File SPR-1995-113

Location: SE Corner 12<sup>th</sup> & Boulder Cliff

Project Name: Concord Station

FILE: #SPR 95-113  
DATE: June 22, 1995  
STAFF: Michael Drollinger  
REQUEST: Site Plan Review - Concord Station  
LOCATION: SE Corner of 12th & Bookcliff  
ZONING: RMF-64

**CONCORD STATION**  
SITE PLAN/UTILITY COMPOSITE  
12th Street and Bookcliff Ave.  
Grand Junction, CO 81501

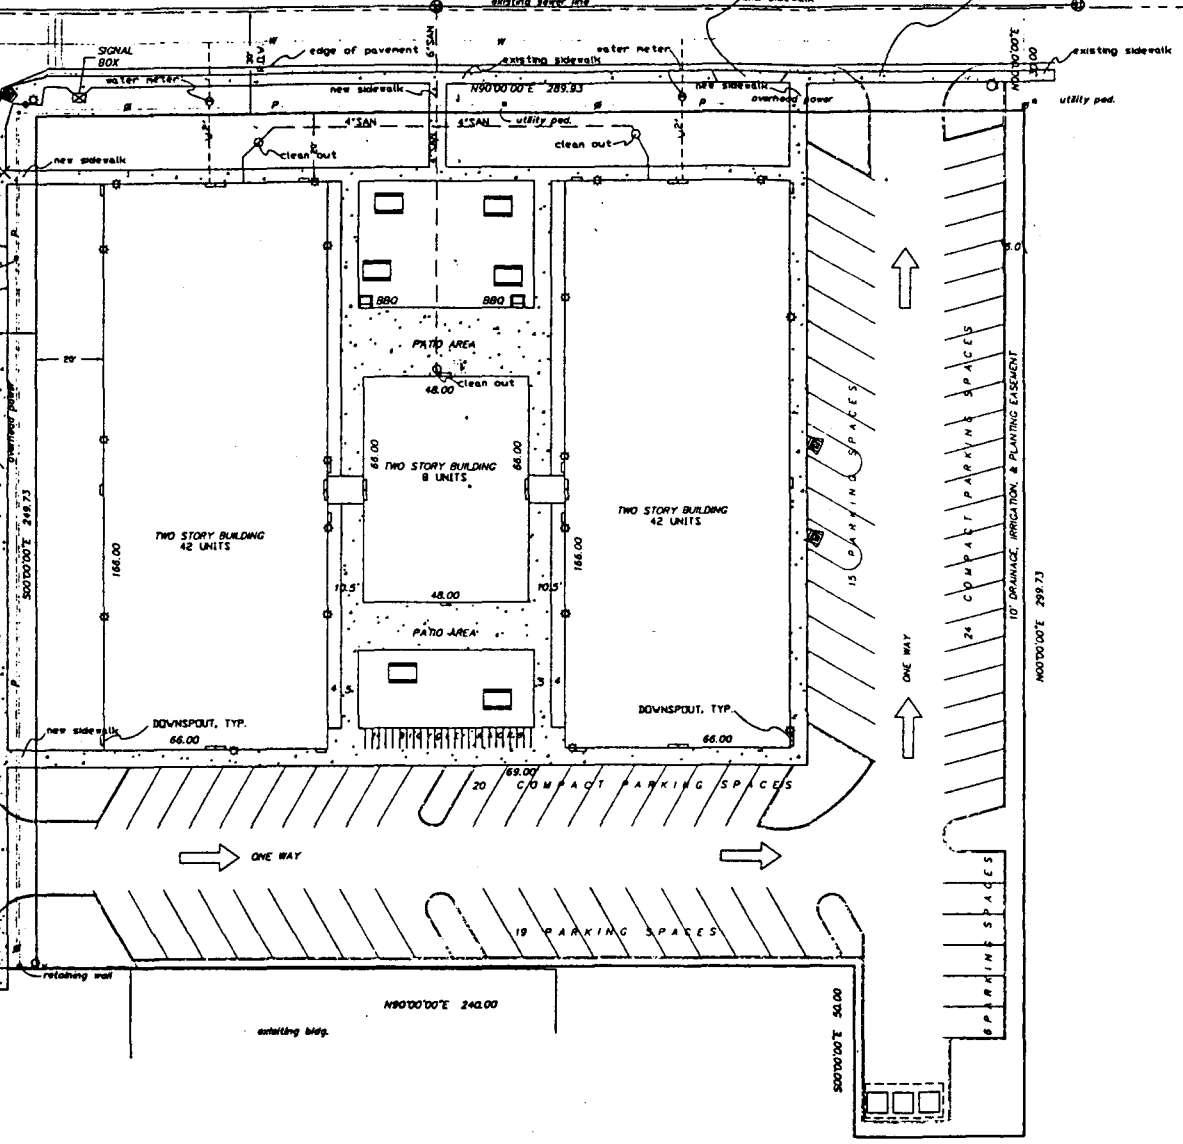
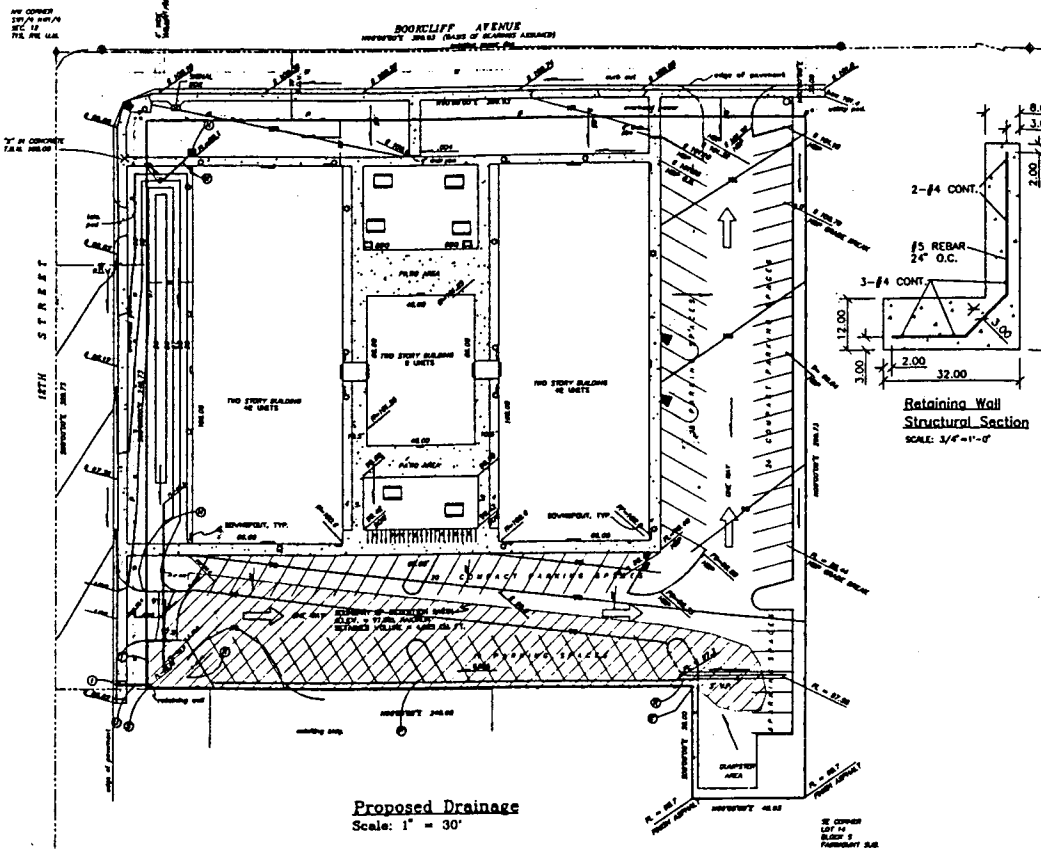
1. Site Plan comments: A checklist from SSID is attached. Circled items need to be addressed on the site plan.
2. The parking dimensions as shown do not work and do not meet the code requirements. Angled parking will work and will emphasize the one-way circulation. At the driveway on 12th, it must be designed to emphasize the one-way entrance only - the 30' radius is not acceptable.

3. The existing curb cut on 12th Street (not shown on the site plan) must be closed. A permit is required for all work in the right-of-way and must be accompanied by a detailed plan of the work. All concrete work - sidewalk, driveway, etc. - must be designed so that it meets City and ADA standards for accessibility.

1. Contact Utility Billing (244-1580) to verify potential change in sewer fees. A building permit will not be issued until the planning clearance is complete which includes Utility Billing signoff. Please provide information on number of units and the capacity of students.
2. Please show location and diameter of proposed sewer connections.

1. Please show diameter of water service line.

1. Parking is the single largest issue with this project, as it has been since its inception. The plan shows 50 of the 91 proposed parking spaces as compact spaces. Several problems with this are this number exceeds the 20% allowed in the TEDS Manual, the TEDS Manual does not allow compact parking for this type of use, and the spaces shown on the south side of the buildings will not function. The aisle width required for 90 degree

parking is 24'. When you lay a turning template on the drawing, vehicles are encroaching on the spaces across the aisle in order to get out of the space. The spaces will function by angling the parking as is shown on the east side of the property, however, some spaces will be lost.

2. The parking space nearest the dumpster area will not work with a dumpster in the way and must be eliminated.
3. City standard curb cuts must be constructed for entry and exit to the site. Exhibit E is attached which shows the standard curb cut. The plan must be redrawn to show the standard curb cuts.

4. The plan calls for one of the existing curb cuts to be abandoned. Both existing curb cuts (one on 12th St., one on Bookcliff) must be removed and replaced with City standard curb, gutter and sidewalk. All work in the right of way will require a permit from the City Engineer's office prior to construction.

5. The site plan needs to clearly indicate which is existing sidewalk and which is new sidewalk to be constructed. A detail for the new sidewalk is required.

6. What is the purpose of the lines shown adjacent to the curb in the parking stalls?
7. Please provide a detail of the retaining wall and show the extent of the wall construction on the drawing.

8. What is the purpose of the 6' Drainage, Irrigation & Planting Easement? Since this is all one ownership, is it necessary?
9. The drainage plan and report is acceptable and appears to be a better design than previously submitted. However, the drainage plan appears to be a reduced version, not a 20 scale as indicated. This needs to be changed on the drawing - either remove the scale or provide a scaled drawing.

10. On the Outfall Piping Detail, please relabel the curb grating as a sidewalk drain trough for clarity and continuity with the other details.
11. Why is the sewer line shown beneath the building?

The site plan has been revised to include all of the items required on the SSID checklist.

Parking dimensions have been revised to meet City code as shown on the revised site plan and the entrance radius has been reduced to emphasize the one-way traffic flow.

The revised plan shows the location of the existing curb cut on 12th Street and notes that it will be abandoned. The appropriate concrete and ADA construction notes have been included on the revised plans.

Petitioner proposes a total of 92 units with a student capacity of 184 students. The revised plan shows the location and diameter of proposed sewer and water lines.

1. The parking on the south side has been revised from 90 degree to 60 degree parking, allowing sufficient aisle width. This resulted in a loss of parking spaces. 84 spaces are now proposed.
2. The parking space nearest the dumpster area has been eliminated, providing 6 spaces in that area rather than 7.
3. The plan has been revised to show city standard curb cuts at entry and exit to the site.
4. The plan has been revised to note that both existing curb cuts must be removed and replaced with city standards curb, gutter and sidewalk.
5. The plan has been revised to show existing and proposed sidewalks, and a sidewalk detail

6. Construction lines from the original survey were inadvertently left on the site plan.
7. The drainage plan has been revised to show a retaining wall detail. Flag notes S, S' and T indicate the extent of wall construction.
8. The 6' Drainage, Irrigation and Planting Easement has been eliminated.
9. The drainage plan has been revised to show the appropriate scale.
10. The outfall piping detail on the drainage plan has been revised to relabel the curb grating as a sidewalk drain trough.
11. The utilities plan has been revised to show the new placement of the sewer line.

**CONCORD STATION**  
Drainage Plan  
12th Street and Bookcliff Ave.  
Grand Junction, CO 81501

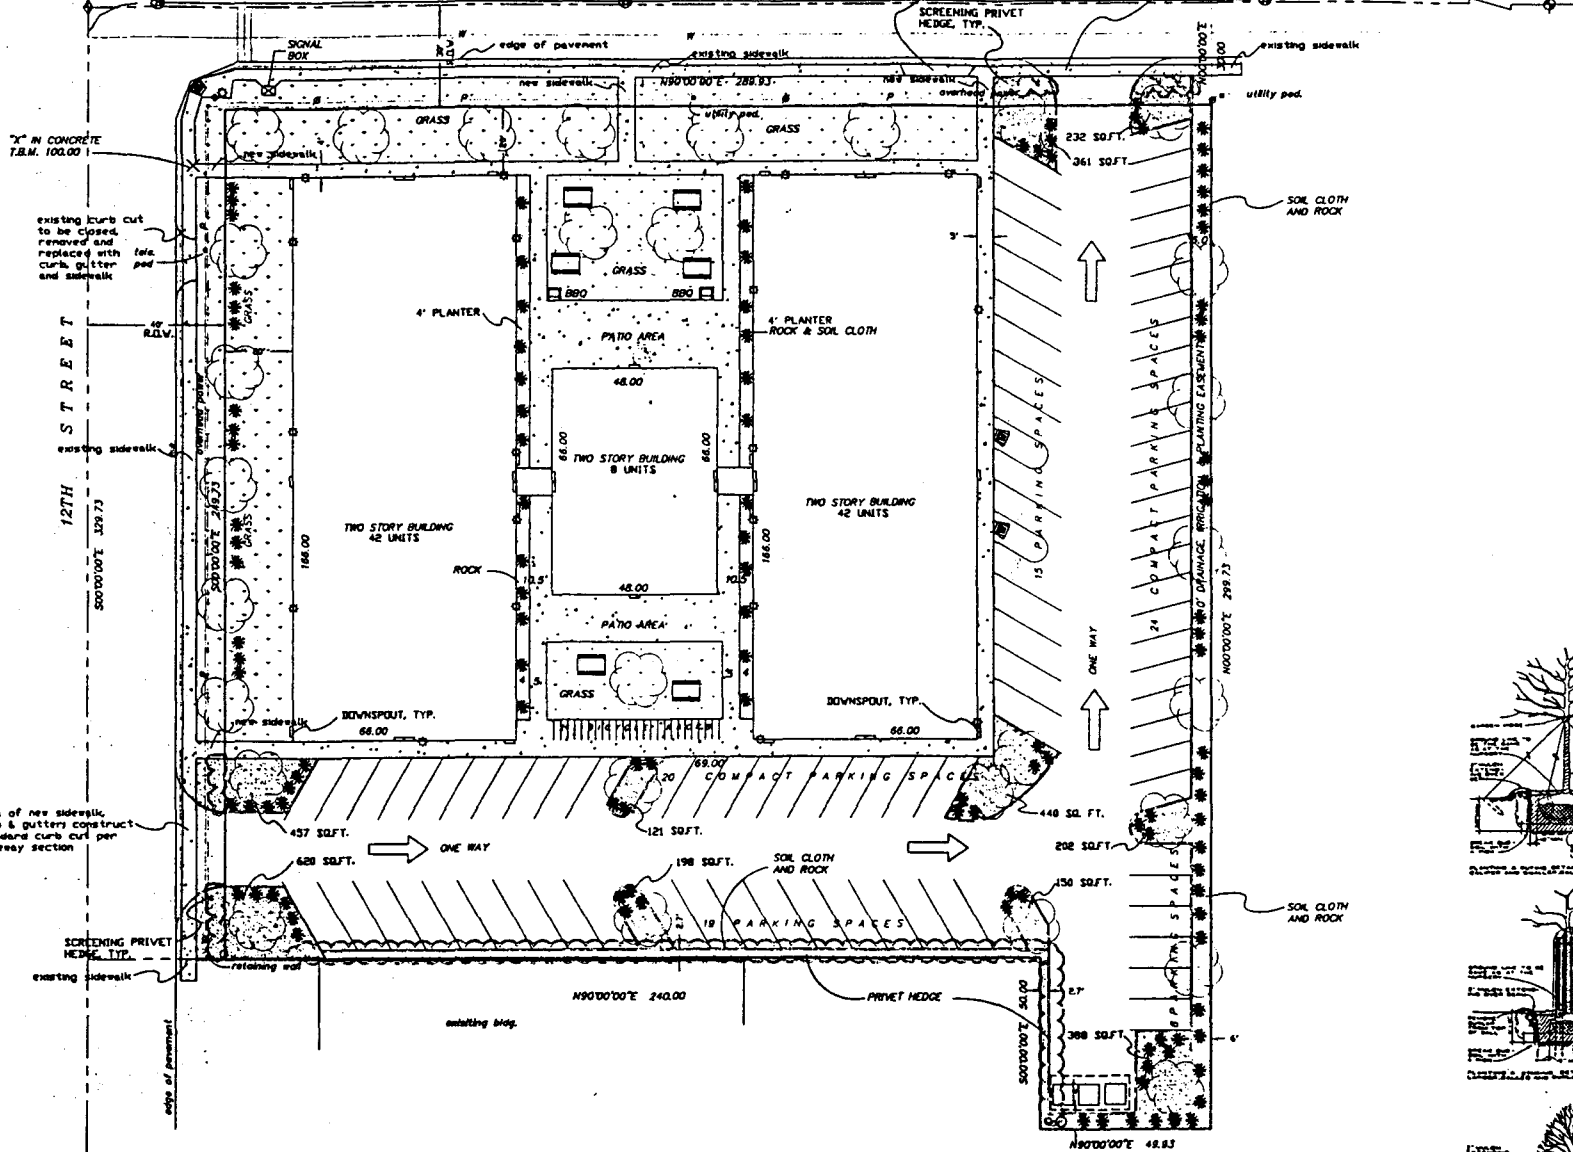
5. Drainage - I do not agree with the calculated runoff as computed for the historic flows. Using the rational method, I roughly calculated the 2 year runoff at .23 cfs and the 100 year at .34 cfs. I have a number of questions and comments shown on the redlined drainage plans (attached). Please have the engineer set up an appointment with me to discuss the plan and revisions.

9. The drainage plan and report is acceptable and appears to be a better design than previously submitted. However, the drainage plan appears to be a reduced version, not a 20 scale as indicated. This needs to be changed on the drawing - either remove the scale or provide a scaled drawing.

10. On the Outfall Piping Detail, please relabel the curb grating as a sidewalk drain trough for clarity and continuity with the other details.

1. The percent of compact spaces provided (over 50%) is still above the maximum of 20% which we will allow for this project. The Code does not permit any compact spaces but we have been flexible in working with you on this issue.
2. On Note "I" of the Drainage Plan, replace "with grate" with "trough".

A revised drainage plan will be submitted.

**CONCORD STATION**  
Landscaping Plan  
12th Street and Bookcliff Ave.  
Grand Junction, CO 81501

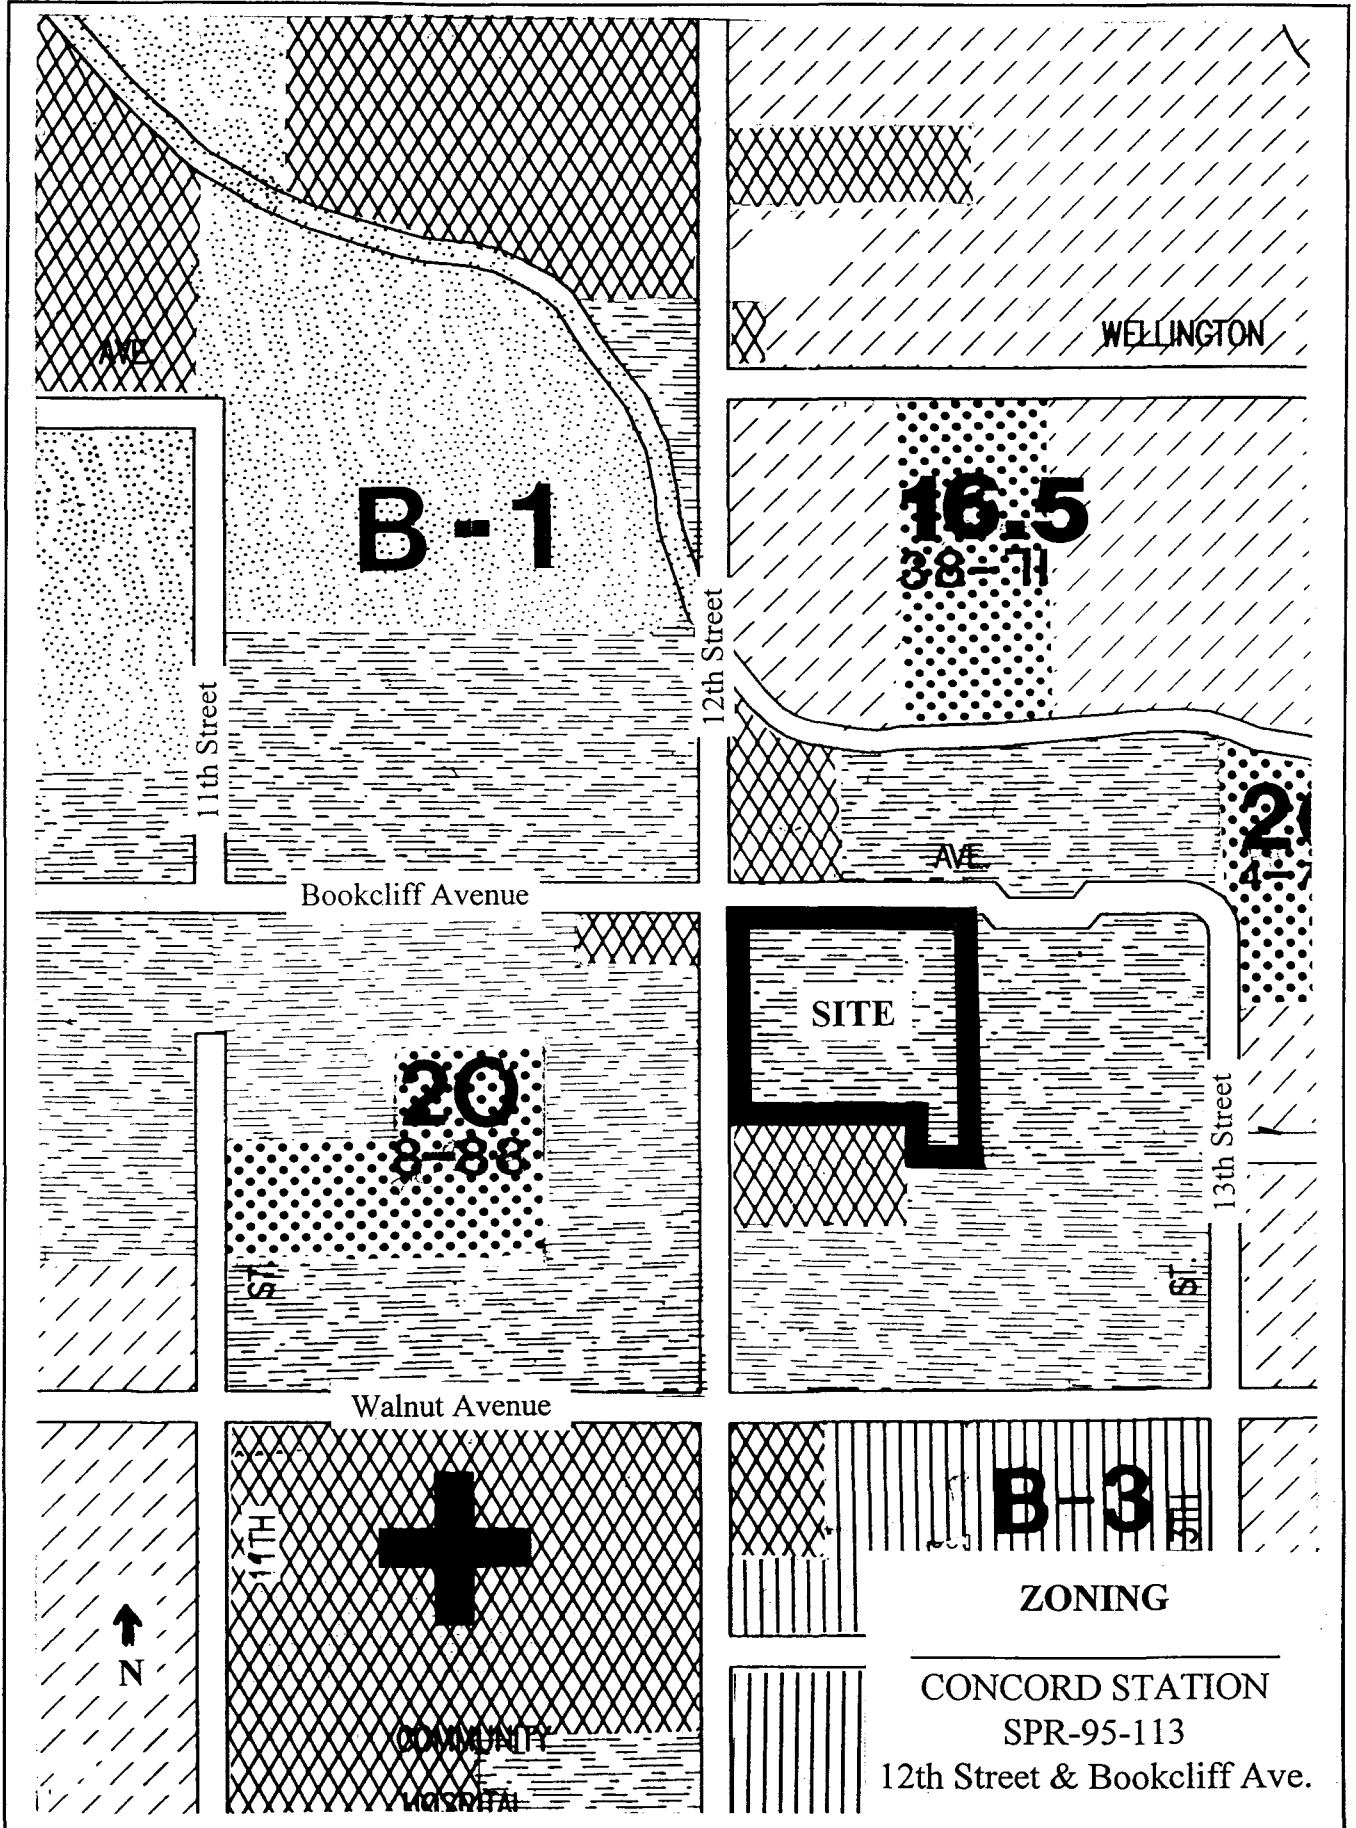
1. Type of rock proposed on landscape plan must be identified; suggest bark as alternative.
2. Interior parking lot landscaping proposed does not meet minimum Code requirements; suggested additions to meet Code, including the addition of a landscape island (required) and the expansion of other landscape areas, are shown on the attached red-lined drawings.
3. Code requires that areas between street and parking lot be bermed to screen parking from road; this may be achieved with landscaping and/or berming of soil. Please detail your proposal on the plans - any berming of soil proposed must be shown on grading plan.
4. Lighting coverage at southeast corner of lot is inadequate; please modify the Lighting Plan to meet minimum Code requirements.
5. Comment #1 of original comments was not addressed in resubmittal. Please provide written response.

A revised landscape plan has been submitted that includes the items required on the SSID checklist. Interior parking lot landscaping has been revised to include planting islands. A lighting plan has also been submitted.

1. Per discussions with Bookcliff Garden, the preferred groundcover for landscaped parking islands is 1"-2" washed rock.
2. The landscape plan has been revised to expand the landscaped parking islands as suggested by staff and an additional island has been placed in the south parking row.
3. The landscape plan has been revised to provide hedge screening of the parking lot from the street.
4. The lighting plan has been revised to show adequate coverage at the southeast corner of the lot.
5. The facility will be privately owned and operated.
